KEYSTONE PIPELINE PROJECT - U.S. PHASE IV (STEELE CITY SEGMENT) PIPELINE ROUTE VARIATION FORM			
1 VARIATION TYPE: Pump Station <input checked="" type="checkbox"/> X			
Does this change require Centerline variation? Yes <input checked="" type="checkbox"/> X No <input type="checkbox"/>			
2 LOCATION (Final PS Location): Sketch: Attached Pictures: -			
State: SD Township: 17N Quad Map: Attached		County: Harding Range: 6E Aerial Map: Attached	
Section: 25 Legal (Initial PS loc.): 19-17N-7E Initial PS MP: 333.6 Final PS MP: - Mar 26th, 2010 C.L.			
3 REASON FOR PUMP STATION RELOCATION (Please include reason for move):			
The Greater Sage Grouse has been now listed in the endangered species list by the US Fish and Wildlife Service. The proposed relocation of Buffalo Pump Station (PS-16) is to avoid having any above ground facilities (pump station and access roads) within a 0.6 mile radius (specified by US Fish and Wildlife Service) from the Greater Sage Grouse Leaks. The proposed reroute is to accommodate this relocation.

KEYSTONE PIPELINE PROJECT - U.S. PHASE IV (STEELE CITY SEGMENT) ROUTE VARIATION AUTHORIZATION FORM			
Date:	9/14/2010	Tracking Number:	0179-SD-P2-329.3-338.6-S
Descri

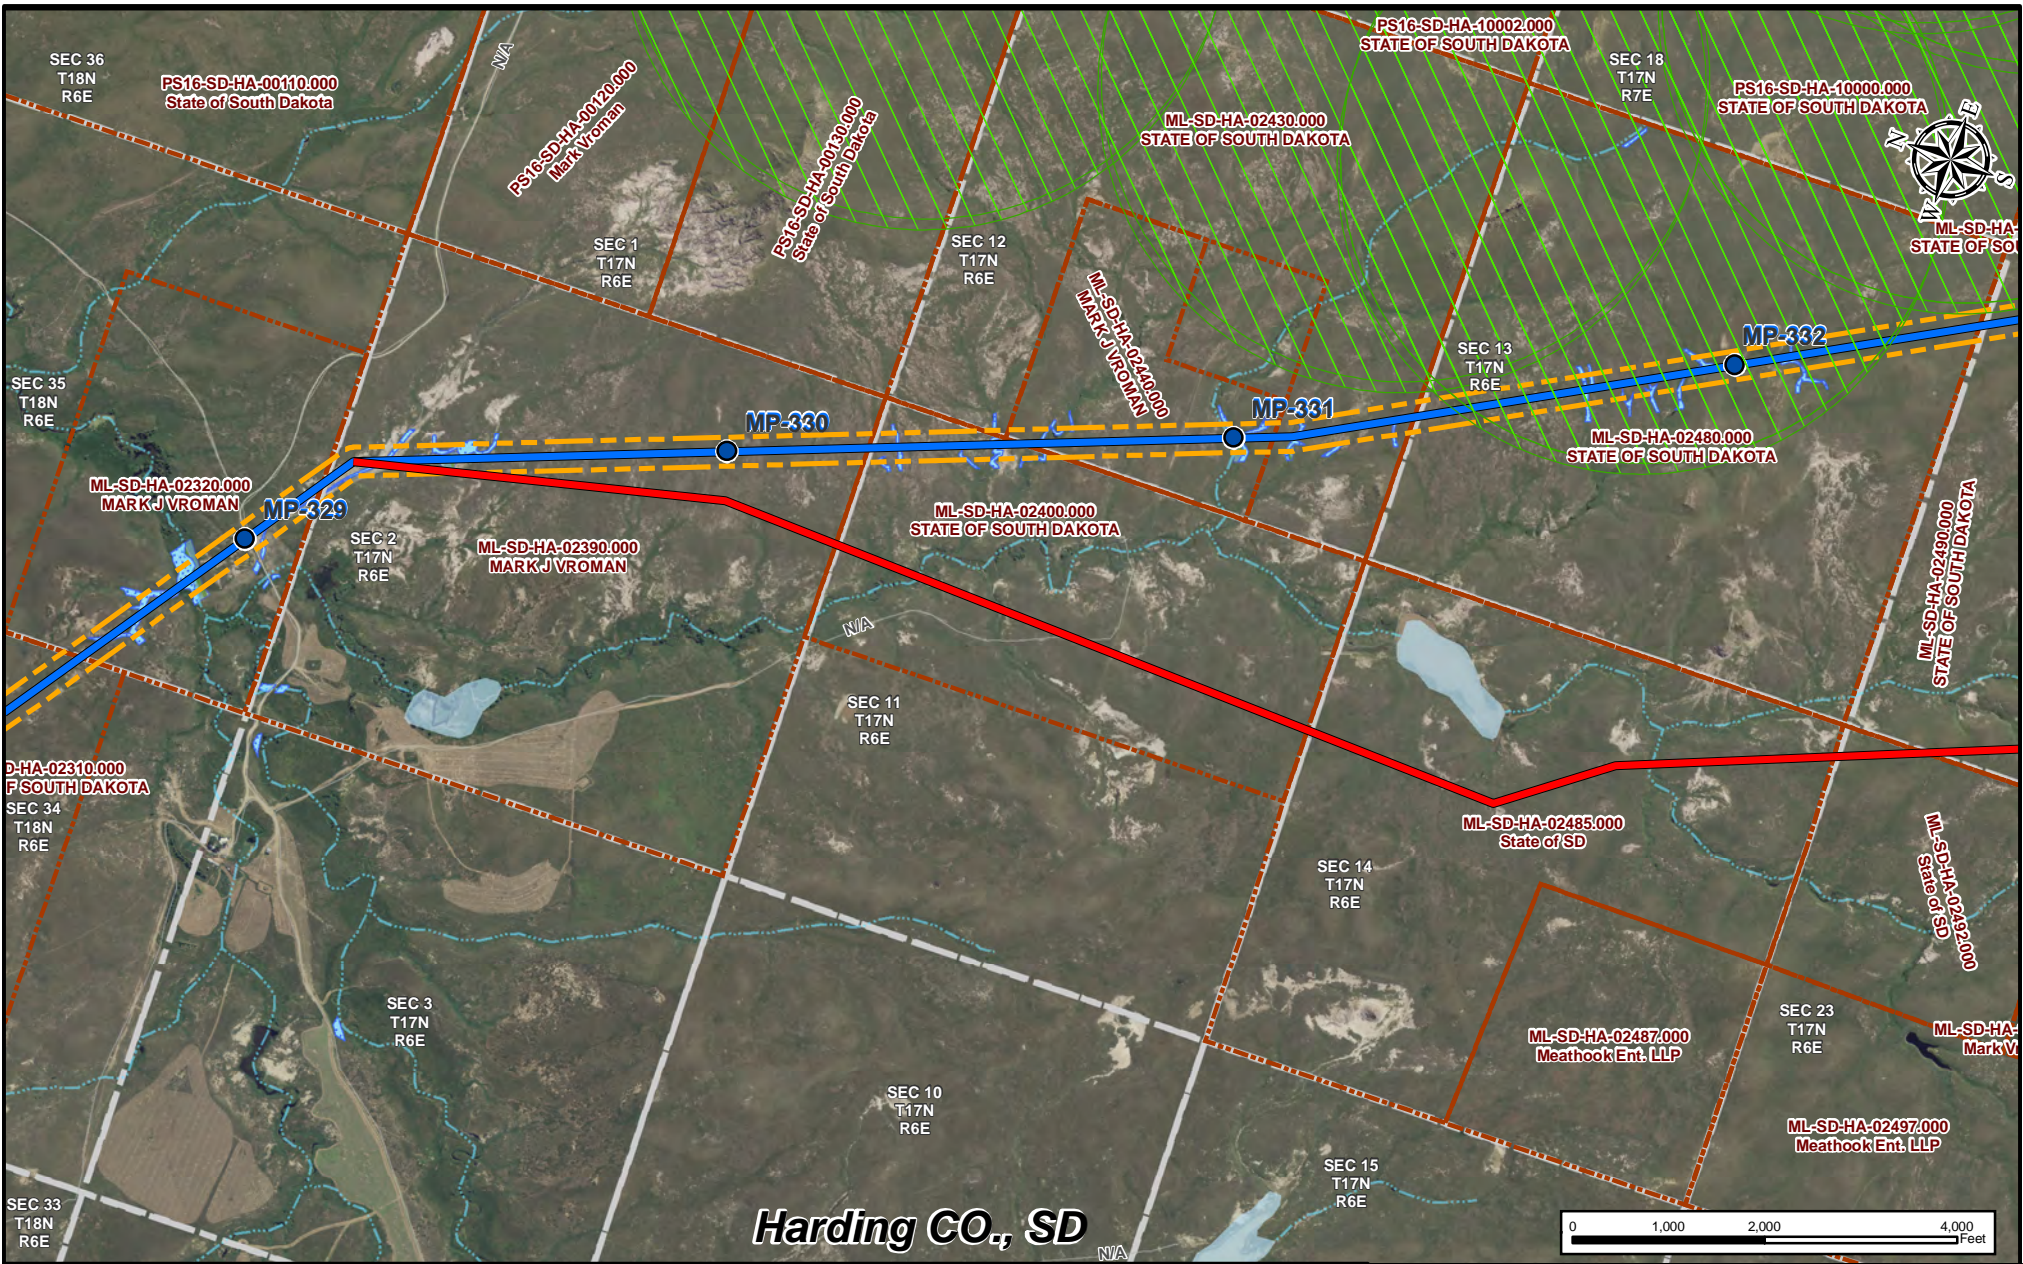
DETAILS OF NEW PUMP STATION LOCATION AND ROUTE VARIATION, IF APPLICABLE (Please describe in detail):			
It is proposed that the Pump Station Buffalo (PS-16) site be increased in acreage to 11.3 Acres from the previous site (8.5 Acres). The pump station has been moved from the southeast corner of the southwest quarter of Sec 19 (T17N-R7E), just north of JB road to the southeast corner of the northwest quarter of Sec 25 (T17N-R6E). The dimensions of the Pump Station have been increased to 760' X 650' from earlier dimensions of 742' X 500'. The proposed reroute starts at the PI near MP 329.3 and deviates towards the south. It continues in this direction for 12,500 ft until it avoids a pond and its sideslopes. Along its path it makes slight a slight deviation to cross a stream feature perpendicularly. The proposed centerline turns towards the southeast and then continues for another ~7,500 ft until it reaches JB road. It then turns towards the south and continues for 3,280 ft (crossing JB road ~5,580 ft west of its current crossing location). Along its path, it passes through the west edge of the proposed PS-16 site. From here, the proposed reroute deviates towards the southeast and continues for 27,470 ft to rejoin the current centerline at the PI near MP 338.6. Along its path, it makes some minor deviations to avoid/cross drainage features at preferred locations.

ADDITIONAL IMPACTS (Please include any additional impacts which may affect cost; routing to pump station, hydraulic impacts, etc.):			
The size of the proposed Pump Station (PS-14) is increased to 11.3 acres from 8.5 acres. The proposed reroute is ~2,605 ft longer than the original route. The additional number of stream crossings are estimated on a desktop analysis. The proposed reroute is based on Desktop analysis and may be tweaked in the field by engineers based on field reconnaissance.			
COST ANALYSIS (costs incurred or saved from the route variation)			
Additional Acreage of the proposed Pump Station site	2.9 acres	\$ 11,600.00	\$4,000/ac
Additional length of route realignment:	2,605 ft.	\$ 937,800.00	\$ 360/ft
Additional length of side-hill construction:		\$ -	\$ 19/ft
Additional length of wetland construction:		\$ -	\$ 195/ft
Additional bore length (Road, RR):		\$ -	\$ 540/ft
Additional foreign line/pipeline crossings:		\$ -	\$ 30,000/EA

e) Environmental features:			
Added (+): None at PS-16 site, unknown on reroute.		Subtracted (-): Avoids 0.6-mile Sage Grouse NSO, avoids multiple intermittent and ephemeral waterbody crossings.	
7 POWER INFRASTRUCTURE TECHNICAL <i>Larry Sibbald</i>

Comments:	The route to the new site still requires environmental survey.	<i>Jonathan Minton</i>	Date: 9/15/2010
		If Rejected Why?	
Power Infrastructure Technical	Larry Sibbald	Variation:	Approved <input type="checkbox"/> Rejected <input type="checkbox"/>
Comments:		<i>Name?</i>	Date:
		If Rejected Why?	
Project Management	Butch Wallace	Variation:	Approved <input checked="" type="checkbox"/> Rejected <input type="checkbox"/>
Comments:		<i>R.E. Wallace</i>	Date: 9/20/2010
		If Rejected Why?	
Stakeholder Relations	Bud Anderson	Variation:	Approved <input type="checkbox"/> Rejected <input type="checkbox"/>
Comments:		<i>Name?</i>	Date:
		If Rejected Why?	
Facilities:	Sandra Gigovic	Variation:	Approved <input checked="" type="checkbox"/> Rejected <input type="checkbox"/>
Comments:	Final hydraulic impact of the relocation will need to be reviewed once final pump station mileposts are available.	<i>Sandra Gigovic</i>	Date: 9/30/2010
